DAVIS-BESSE NUCLEAR POWER STATION, UNIT NO. 1

Amendment No. 42
License No. NPF-3

ATTACHMENT TO LICENSE AMENDMENT NO. 42

SAFETY EVALUATION BY THE OFFICE OF NUCLEAR REACTOR REGULATION
SUPPORTING AMENDMENT NO.42 TO FACILITY OPERATING LICENSE NO. NPF-3

3.1.3.6 The regulating rod groups shall be limited in physical insertion as shown on Figures 3.1-2a, 2b and 2c and 3.1-3a, 3b and 3c, with a rod group overlap of $25 \pm 5\%$ between sequential withdrawn groups 5, 6, and 7.

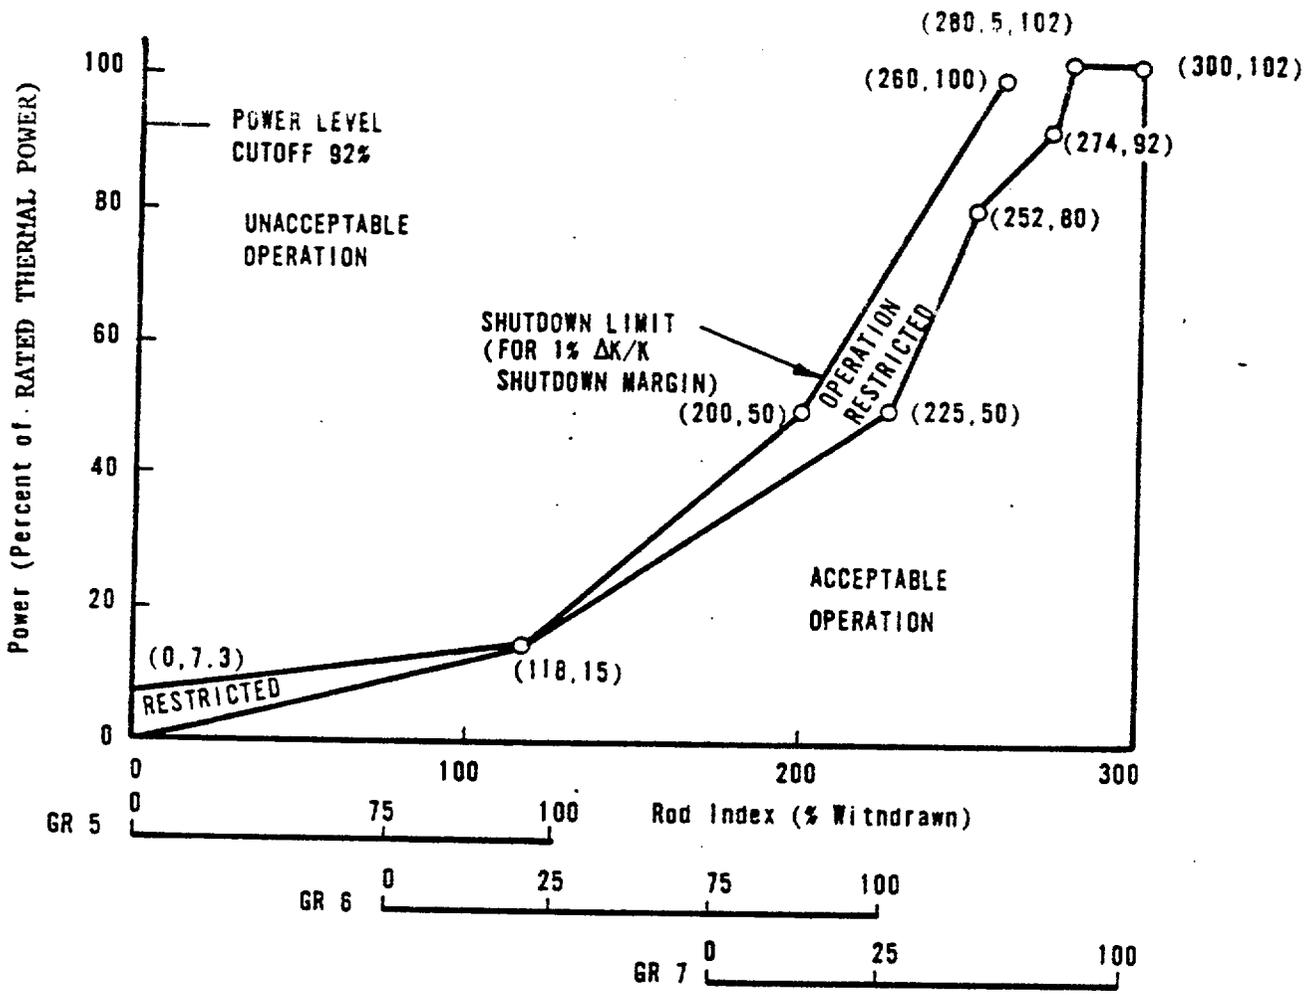
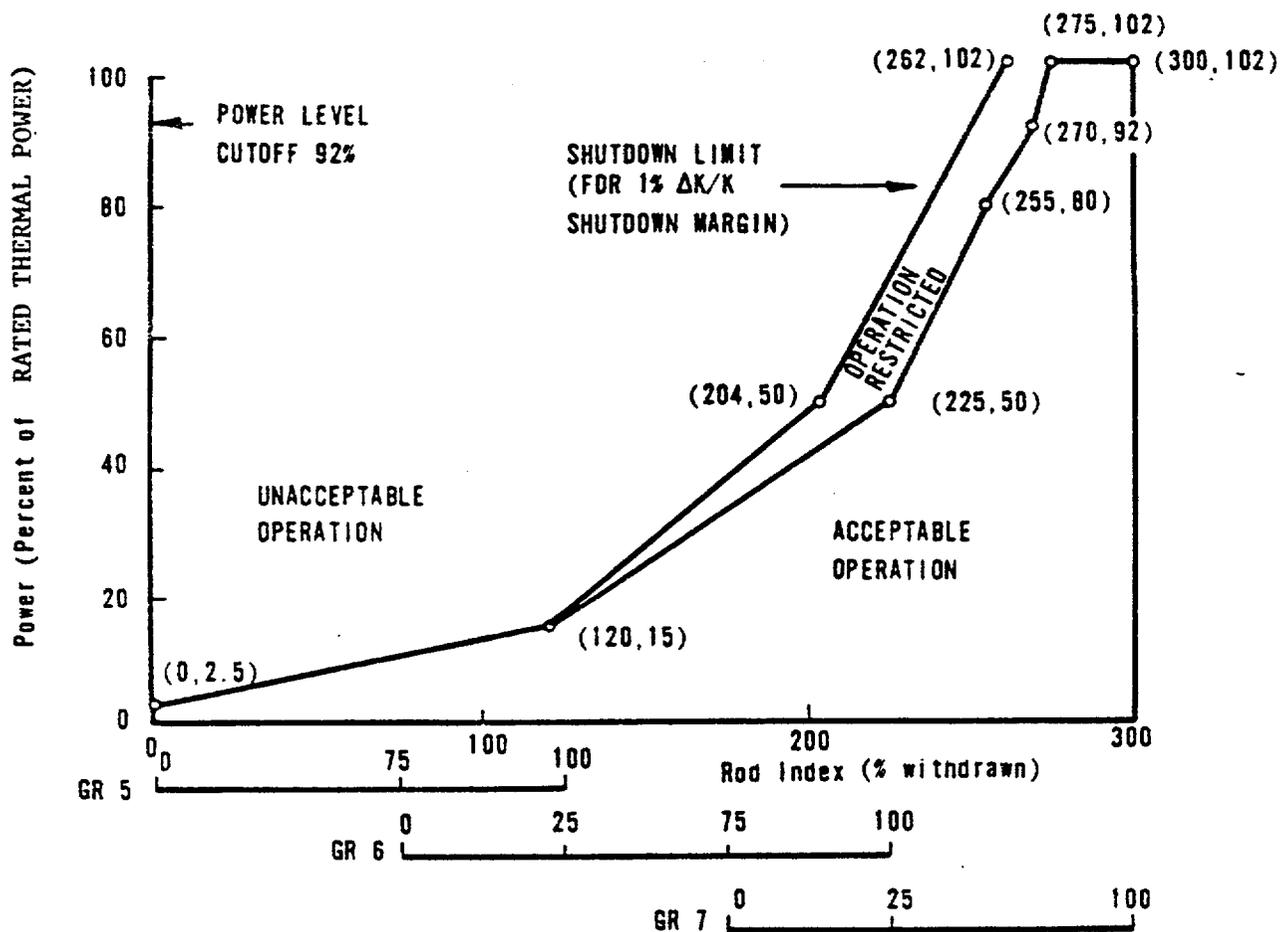
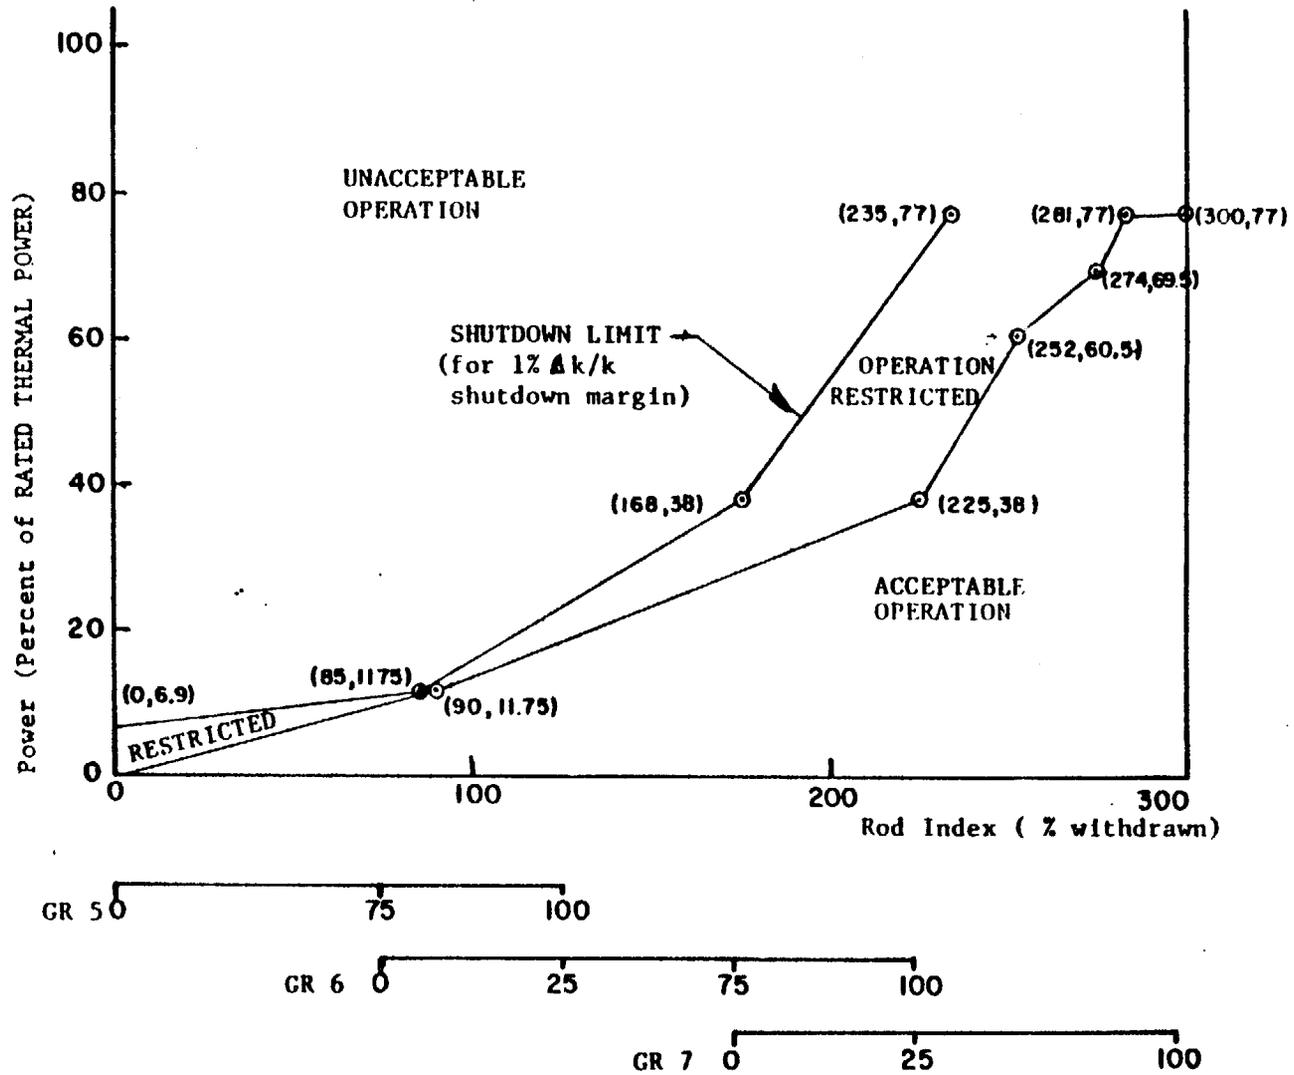
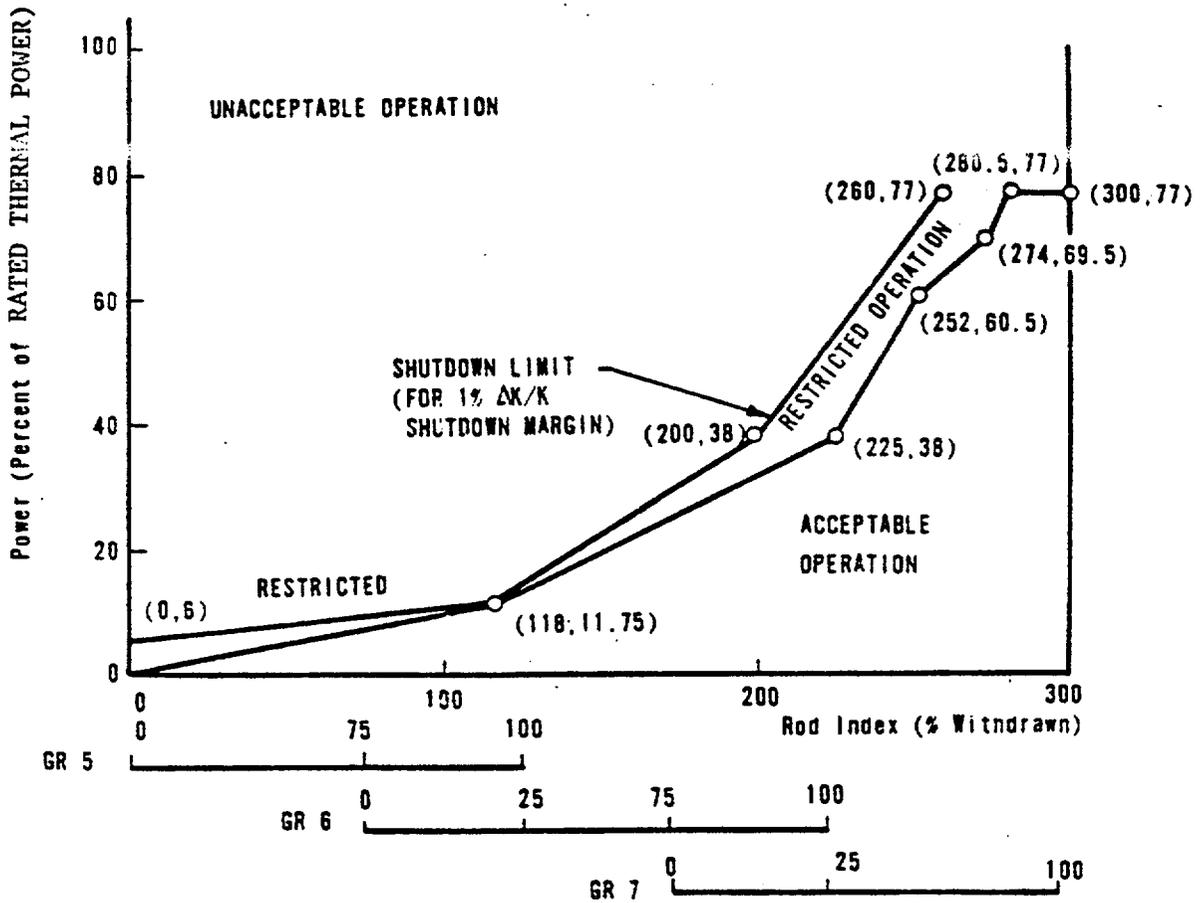
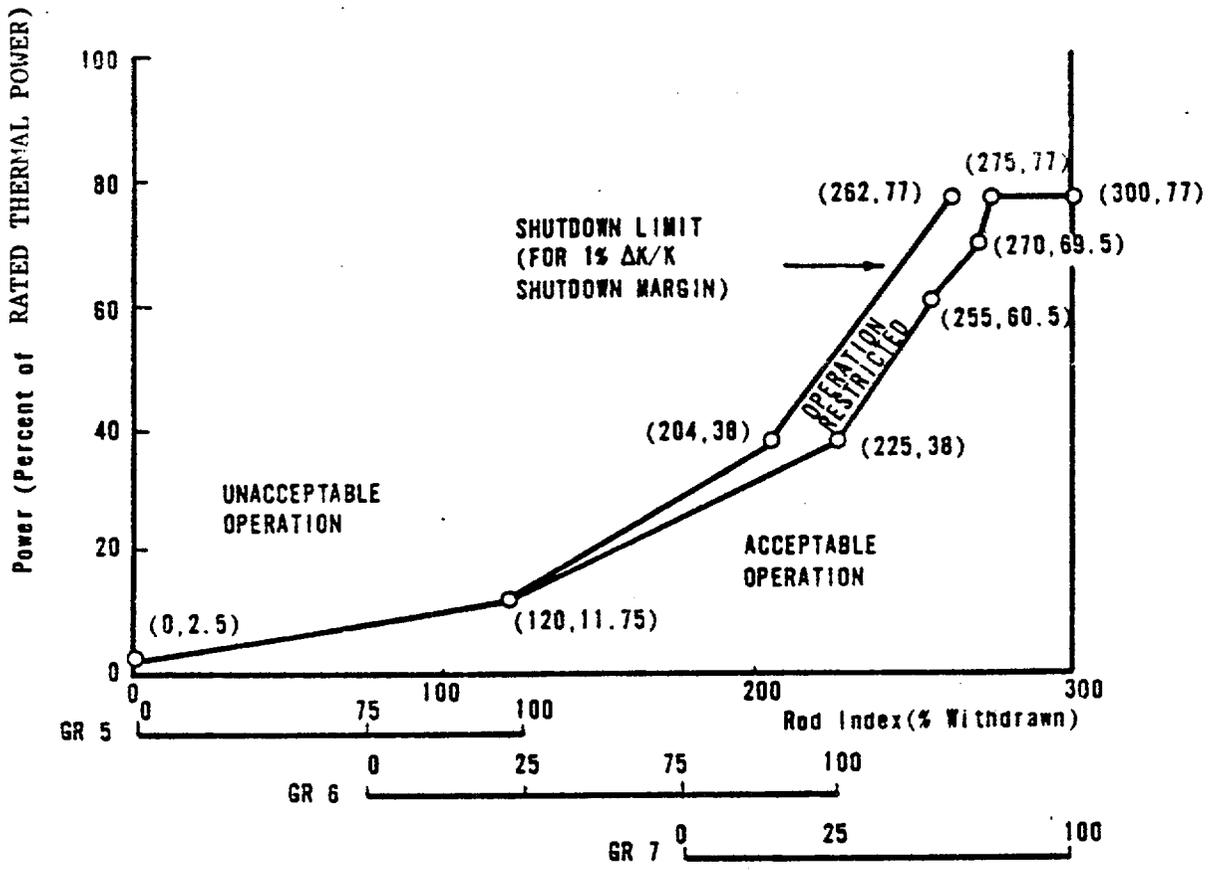
With the regulating rod groups inserted beyond the above insertion limits (in a region other than acceptable operation), or with any group sequence or overlap outside the specified limits, except for surveillance testing pursuant to Specification 4.1.3.1.2, either:

- a. Restore the regulating groups to within the limits within 2 hours, or
- b. Reduce THERMAL POWER to less than or equal to that fraction of RATED THERMAL POWER which is allowed by the rod group position using the above figures within 2 hours, or
- c. Be in at least HOT STANDBY within 6 hours.

The same techniques and models were used to derive the revised TSs for limiting conditions of operation as were used to derive those for Cycle 1 and the original Cycle 2 submittal. The modified TSs required to operate beyond 250 EFPD by completely withdrawing the axial power shaping rods and coasting down in power level to the EOC (approximately 306 EFPD) have been reviewed and discussed with Teco. On the basis of these discussions and the fact that previously approved methods are used, we conclude that the new specifications, to accommodate extended Cycle 2 operation to

306 + 10-30 EFPD if required by complete withdrawal of the axial power shaping rods at approximately 250 EFPD and coasting down in power level, are acceptable.
